ADDENDUM NO. ONE  
PROJECT TITLE: PATH REPLACEMENT  
GLEN OAK LAGOON

ISSUANCE DATE: JUNE 13, 2024

**PATH REPLACEMENT at  
 GLEN OAK PARK LAGOON**

**"NORMAL CONDITION SECTION"**  
 4" PCC SLAB OVERHANGING  
 BULKHEAD WALL

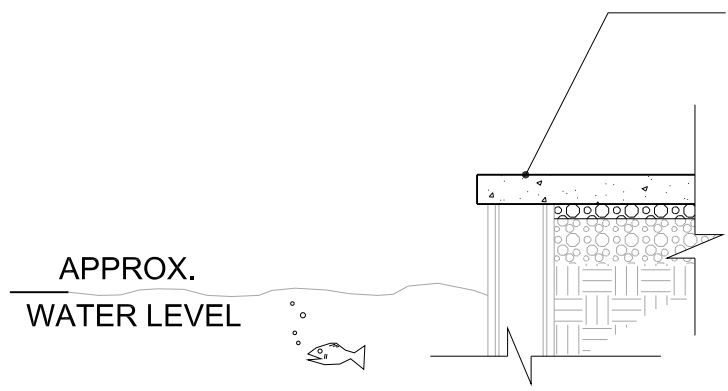
A limited area on the west side of the lagoon with Alternate #1 has heaved bulkhead walls. In order to accommodate that heaving, the new concrete walk elevation shall be set at the highest “heaved” elevation, and sloped at a maximum of 4% running slope to the “normal” condition on either side of the heaved sections. Compacted CA-6 gravel base will be used to make up the difference in elevation under the new walk. A thickened edge will be required in this area to contain the gravel. That thickened edge shall be the same width as the bulkhead wall. Cross slope shall be a maximum 2%, and all work shall be ADA accessible.

See Page two for details of the “normal” condition, the “special” condition, and the transition between the two.
